**FINAL DRAINAGE REPORT
FOR
ELLCOTT TOWN CENTER – FILING NO. 1**

April 19, 2006
Revised June 23, 2006
Revised January 15, 2007
Revised August 24, 2018

SF-18-025

Detention Basin Outlet Structure Design

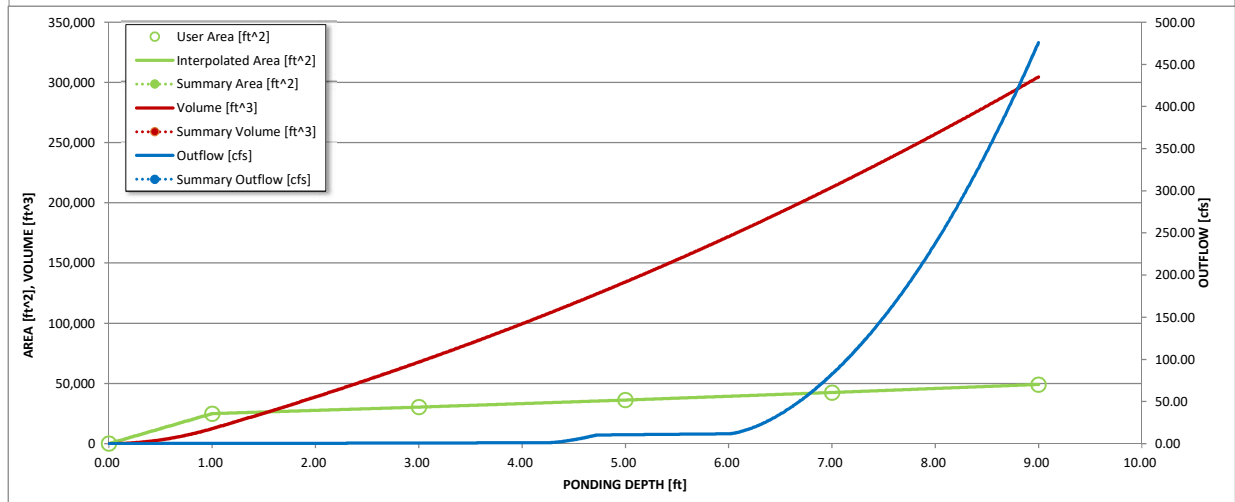
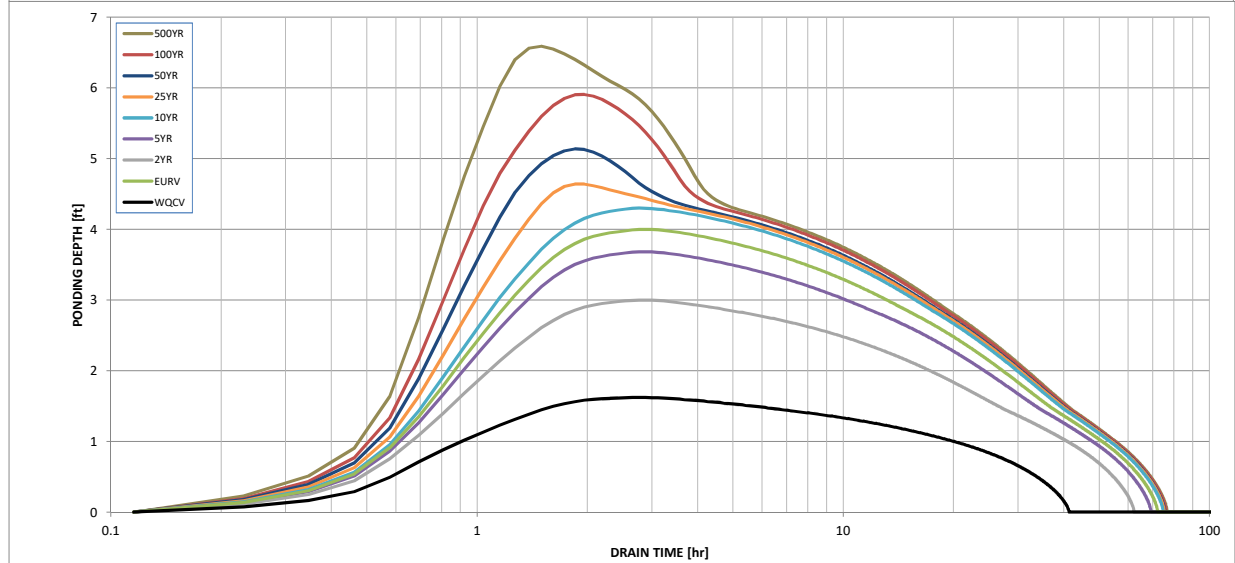
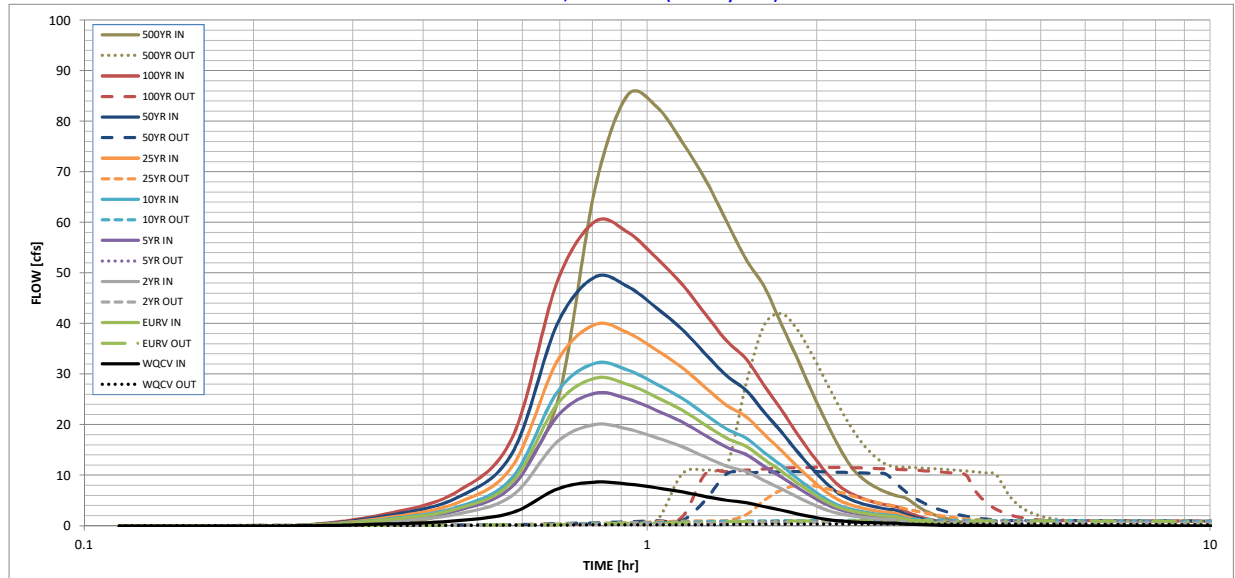
Adjust the outlet to reduce these.

FIGURE A3

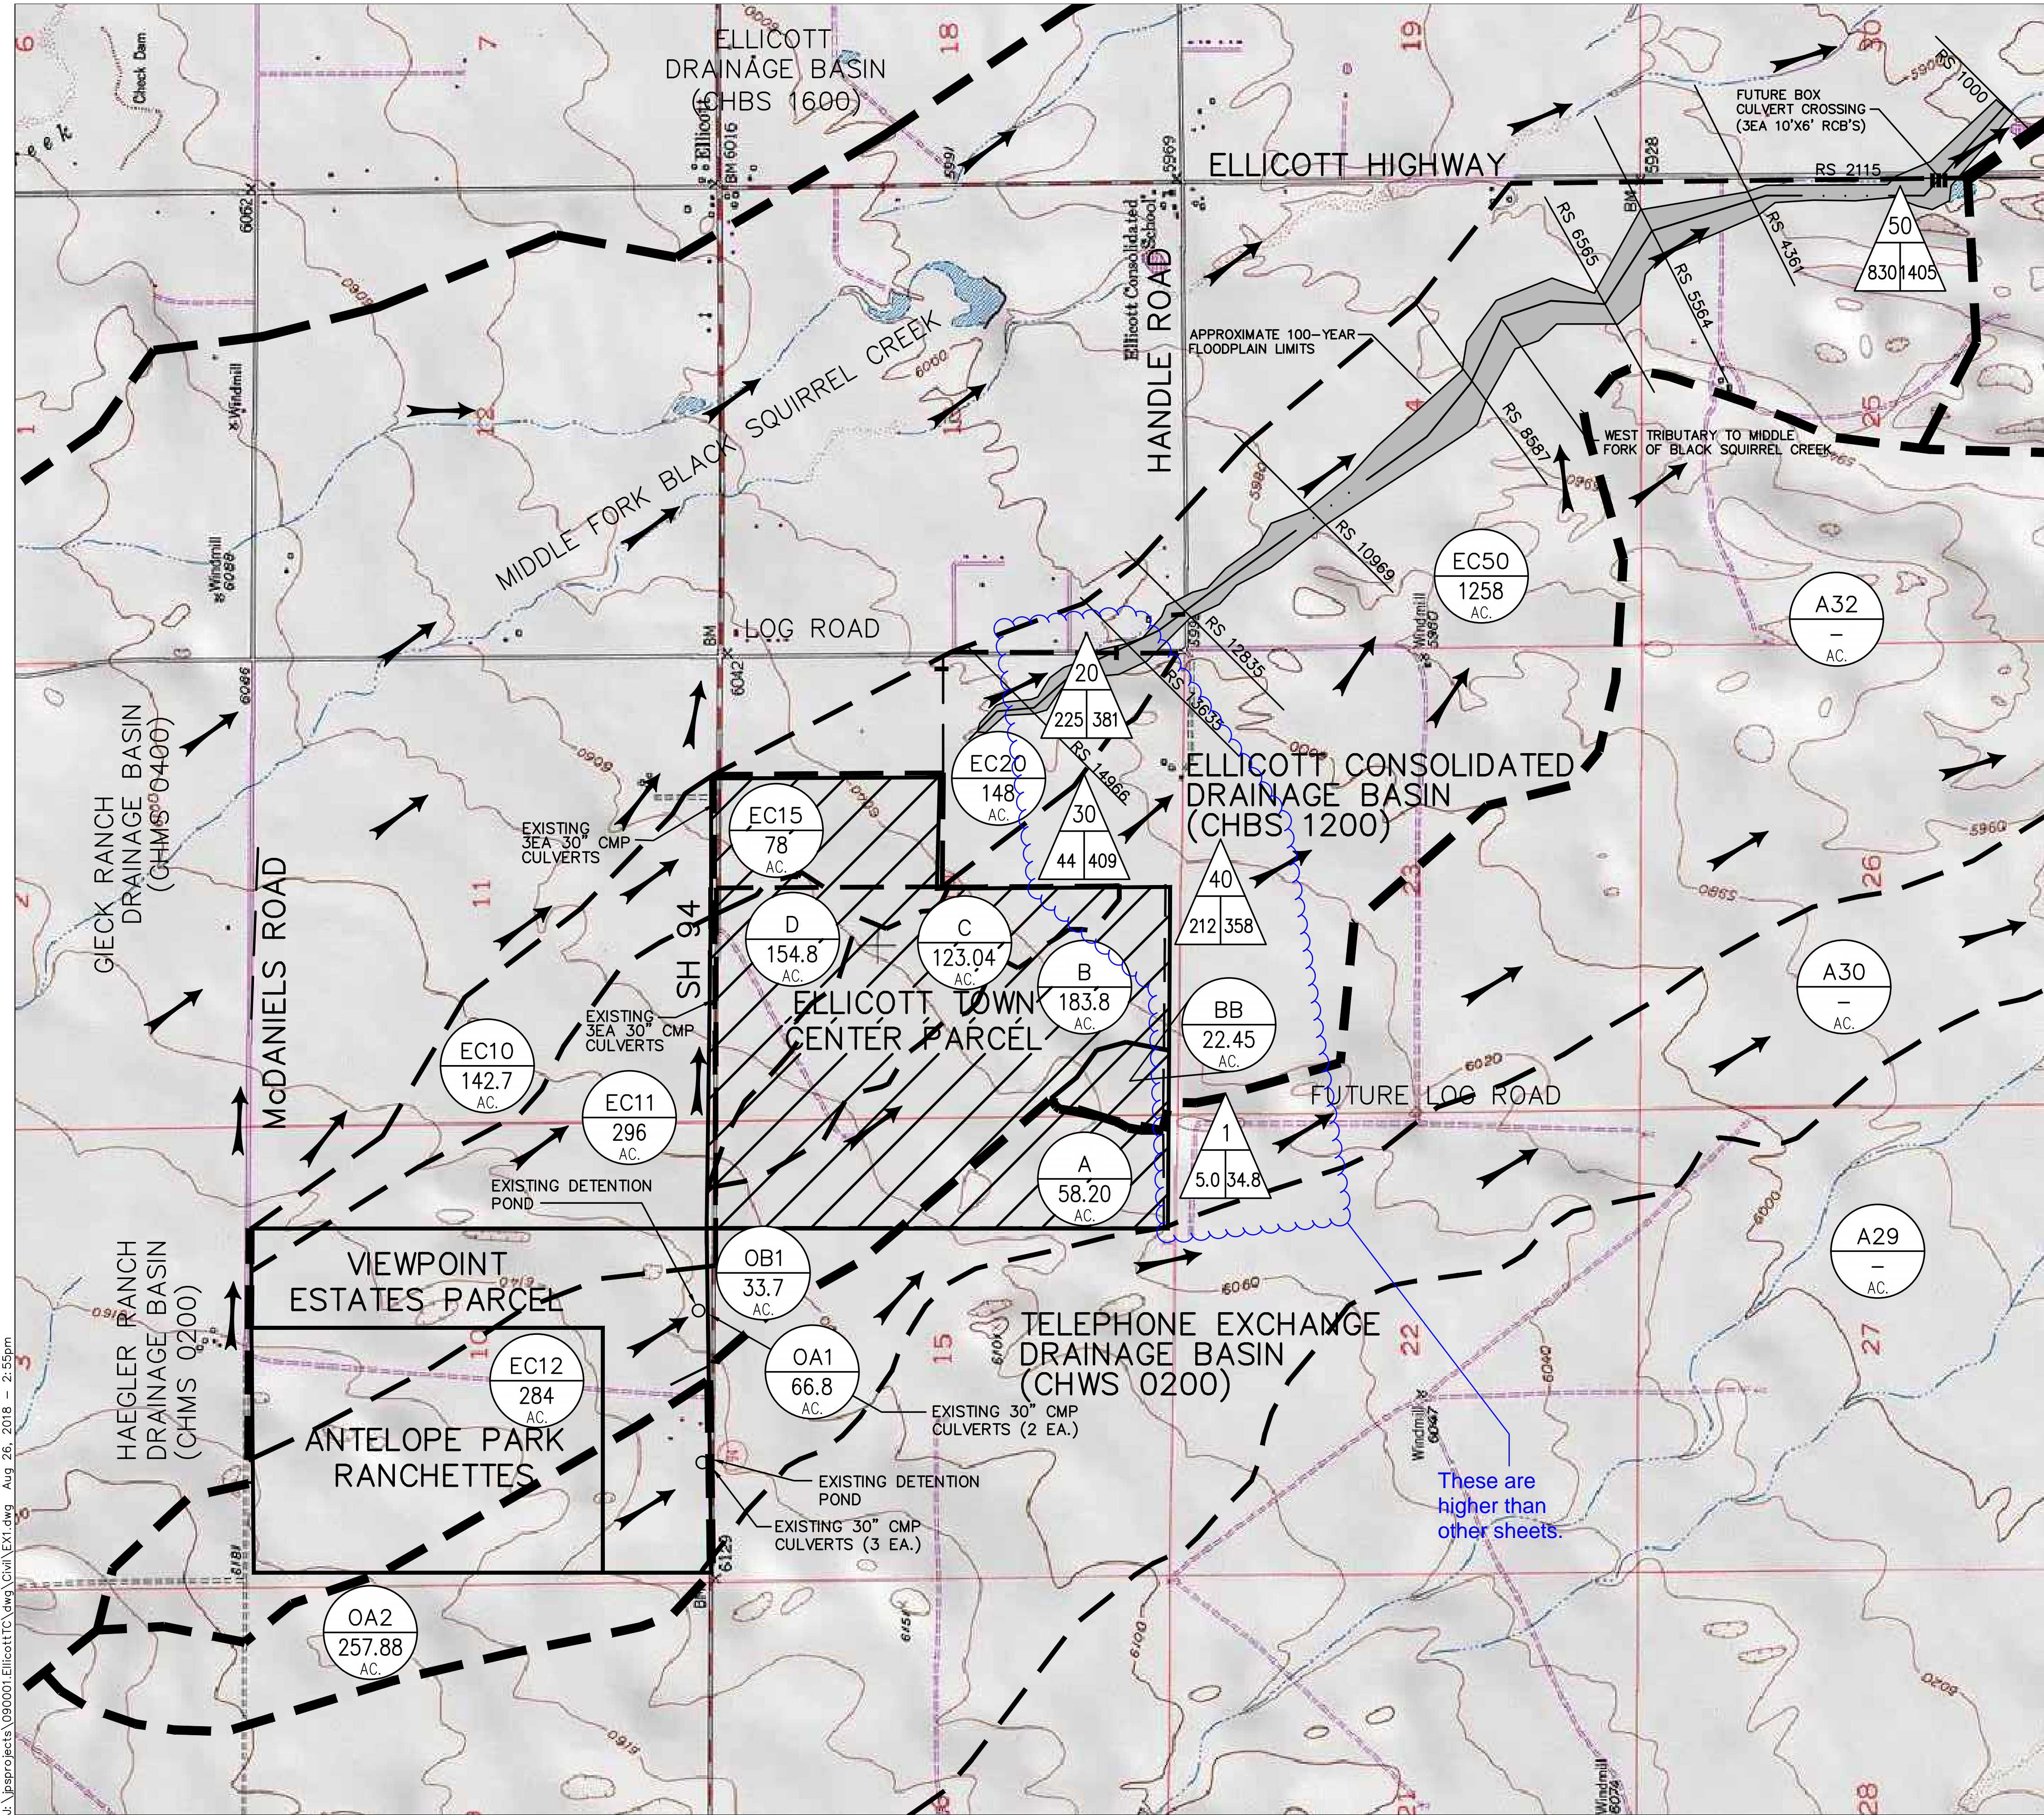
Provide a summary table.

Provide calculations for these flows.

SHEET: **D1.01**

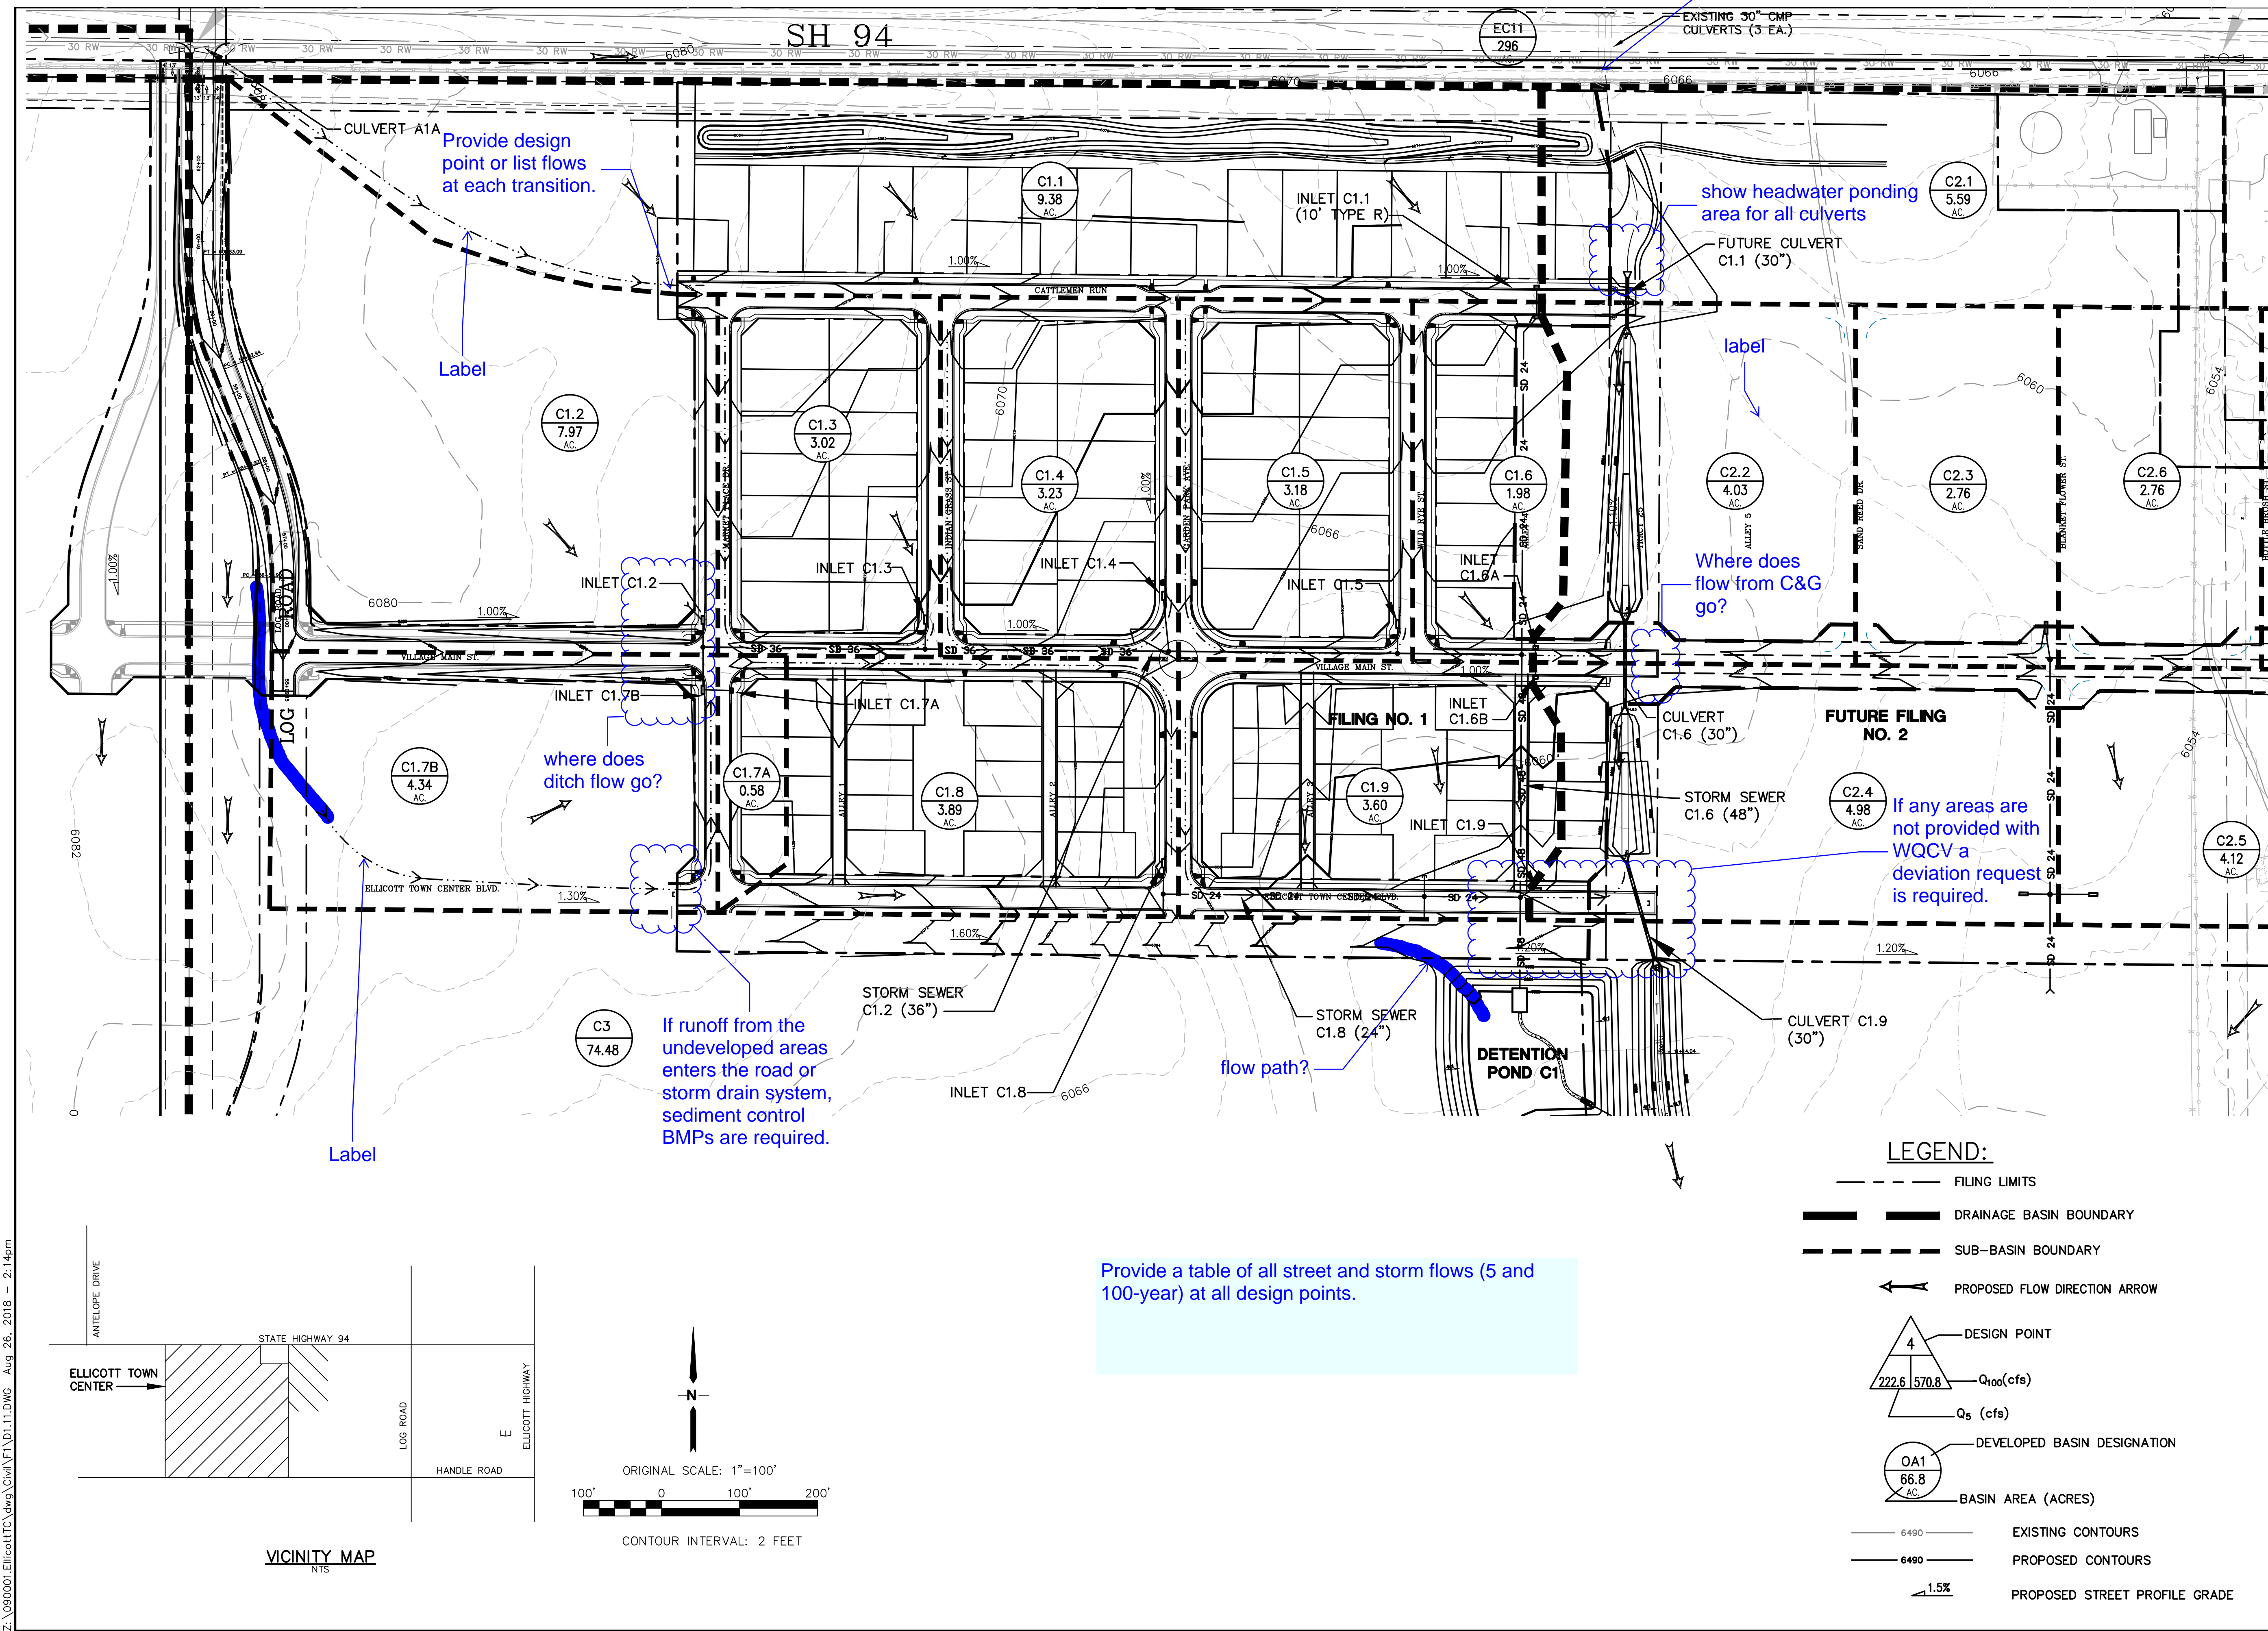
Provide a table of all street and storm flows (5 and 100-year) at all design points.
